Model: PR-C1 (Fax Option)		Date: 19-Jun-07	No.: MD010001
Modified Article: Parts Catalog Correction		Prepared by: M. Ishihara	
From: 1st Tech. Support Sec. Service Support Dept.			
Reason for Modification:	☒ Parts catalog correction ☐ Vendor change ☐ Other ☐ To facilitate assembly ☐ To improve reliability ☐ To meet standards ☐ Part standardization ☐ Product Safety ()

1.Fax Option (D345)

Part Change Information List

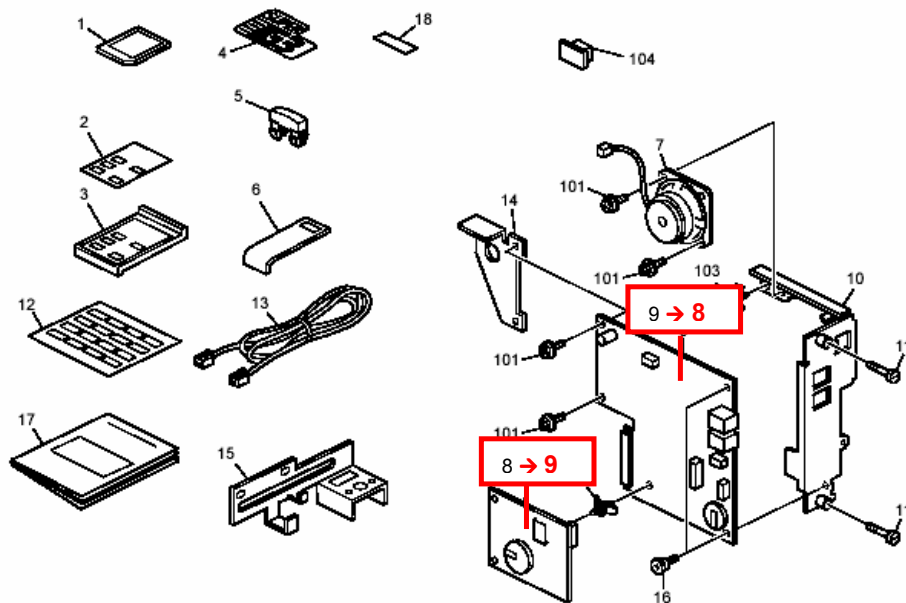
Please correct your parts catalog as follows.

Old part number	New part number	Description	Q'ty	Int	Page	Index	Note
D3455080	-	PCB : MBU : Ass'y	1	-	2	8→9	
B8685172	-	PCB : GWFCU3 : NA	1	-	2	9→8	
B8685174	-	PCB : GWFCU3 : EU	1	-	2	9→8

20.DUPLEX UNIT 1 (D010/D043)

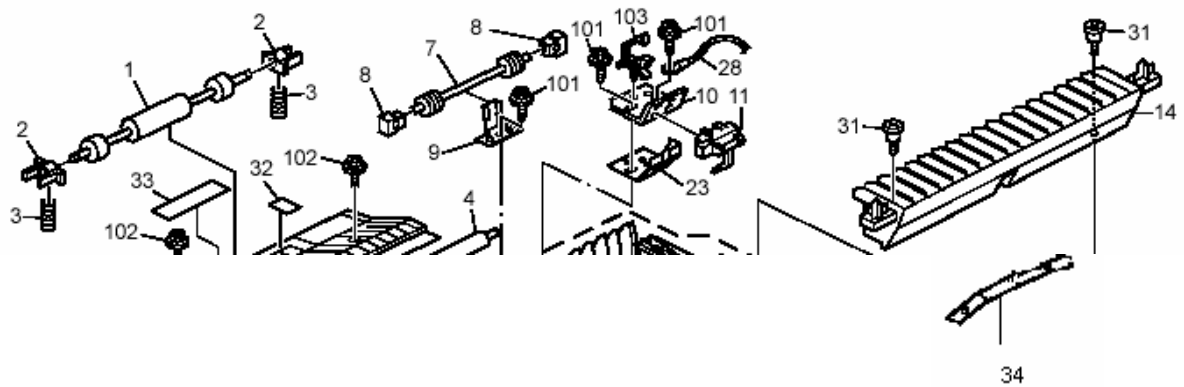
-	B0394485	Grounding Plate – Exit Guide	0-1		45	34	New
B1234670	-	Right Lower Exit Guide Plate Ass'y	1-0		45	14	
B0392558	D0102558	Turn Roller	1-1		45	4	
AA080313	D0104313	Bushing: mm4	6-6		45	8	
<i>B1234670</i>	D0104663	Guide Plate: Exit: Right Lower: Duplex	<i>1-1</i>		45	14	New
B0434633	D0104633	Gear: Idler: Manual Feed	1-1		47	24	
B0434714	D0104714	Gear: Input: Manual Feed	1-1		47	23	
B1234977	D0104977	Guide Plate: Exit: Right Upper Ass'y	1-1		45	25	
B1234691	D0104691	Decal	1-1		45,75	27,6	
AA080268	D0104268	Bushing: mm4: Vertical Transport	2-2		45	2	
B0434713	D0104713	Gear: Manual Feed	1-1		47	25	
B1234617	D0104617	Guide Plate: Duplex: Entrance	1-1		45	23

Change/ Reason: Part number correction. The plate (Index No. 34) sticks to the bottom of the guide plate (Index No. 14).

20.DUPLEX UNIT 1 (D010/D043)

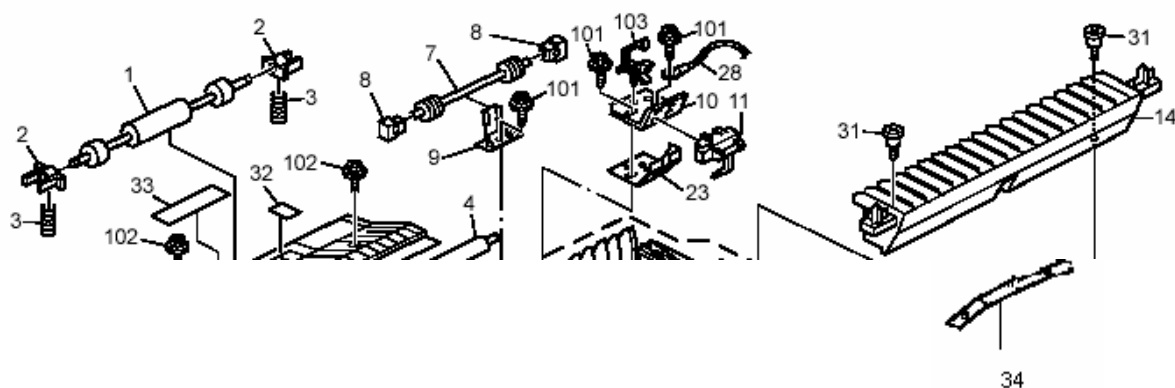
Incorrect part number	Correct part number	Description	Q'ty	Int	Page	Index	Note
B2072773	<i>D0102771</i>	<i>Tension Spring</i>	<i>2-2</i>		<i>55</i>	<i>21</i>	
B0434632	<i>D0104632</i>	Coupled Gear 25/59z	1-1		47	30	
B0392610	<i>D0104510</i>	Bracket - Paper End Sensor	1-1		47	10	
B0434609	<i>D0104609</i>	Stay: Contact Point: Duplex Unit: Adhesion	1-1		47	1	
B2614650	<i>D0104650</i>	Separation Pad: Ass'y	1-1		47	5	
B0434667	<i>D0104667</i>	Guide Plate: Manual Feed: Lower	1-1		47	3	
AB030569	<i>D0104569</i>	Pulley: 30T: Right	2-2		47	20	
B2614623	<i>D0104623</i>	Transport Roller: Drive: Duplex Connecting	1-1		47	7	
B0434631	<i>D0104631</i>	Gear Drive: Transport Roller	1-1		47	18

-	<i>B0394485</i>	Grounding Plate – Exit Guide	0-1		45	34	New
B1234670	-	Right Lower Exit Guide Plate Ass'y	1-0		45	14	
B0392558	<i>D0102558</i>	Turn Roller	1-1		45	4	
AA080313	<i>D0104313</i>	Bushing: mm4	6-6		45	8	
B1234670	<i>D0104663</i>	Guide Plate: Exit: Right Lower: Duplex	1-1		45	14	New
B0434633	<i>D0104633</i>	Gear: Idler: Manual Feed	1-1		47	24	
B0434714	<i>D0104714</i>	Gear: Input: Manual Feed	1-1		47	23	
B1234977	<i>D0104977</i>	Guide Plate: Exit: Right Upper Ass'y	1-1		45	25	
B1234691	<i>D0104691</i>	Decal	1-1		45,75	27,6	
AA080268	<i>D0104268</i>	Bushing: mm4: Vertical Transport	2-2		45	2	
B0434713	<i>D0104713</i>	Gear: Manual Feed	1-1		47	25	
B1234617	<i>D0104617</i>	Guide Plate: Duplex: Entrance	1-1		45	23

Change/ Reason: Part number correction.
